RE: RE: Lot 13 Block 5 Volcano Cliffs Unit 19 SAD 228 6605 Petirrojo Rd. NW

Grading and Drainage Plan

Pad Certification Date 4/8/2022

6605 PETIRROJO ROAD NW GRADING AND DRAINAGE PLAN

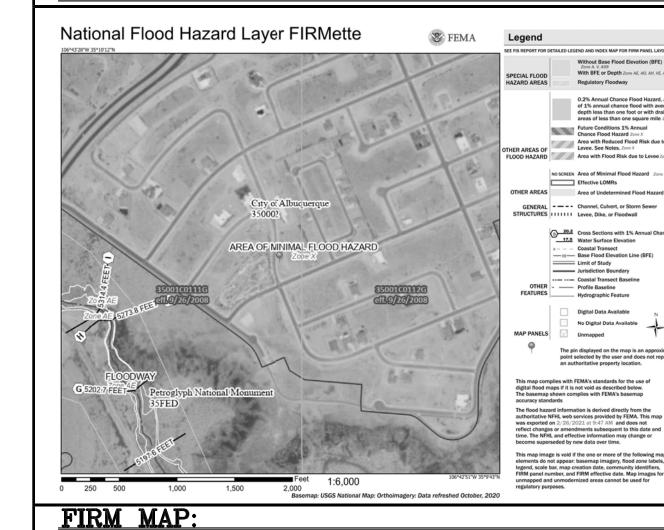
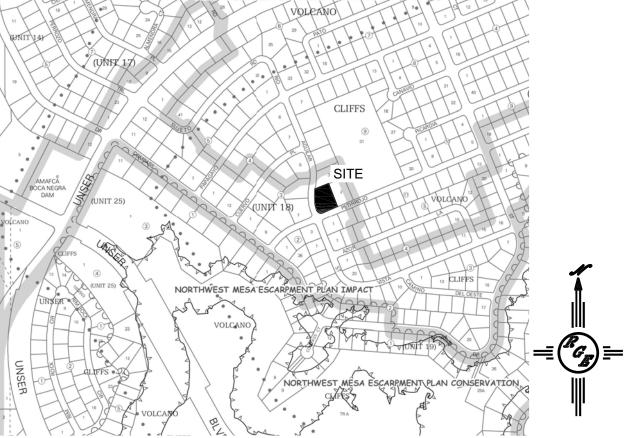
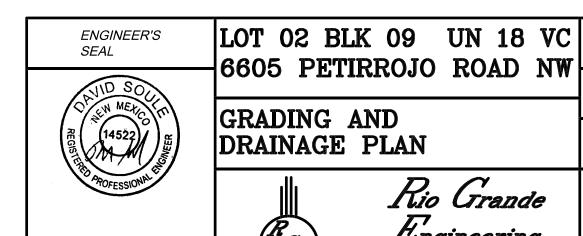
Based upon the information provided in your submittal received 4/12/2022, this plan is approved for Building Permit.

Reiterate to the Owner/Contractor that a separate permit for a garden/retaining wall must be obtained, with the approved G&D plan and Pad Certification. Also, let the owner/contractor know that if a pool is to be added in the future the G&D plan will need to be modified showing the location of the pool and the land treatment differences. Also advise the owner & Contractor that dirt is not allowed in the public right of way to climb the curb. Crusher fines or lumber is allowed. If dirt is used this will delay going forward with the construction of the home.

Prior to Certificate of Occupancy release, Engineer Certification per the DPM checklist of this plan will be required.
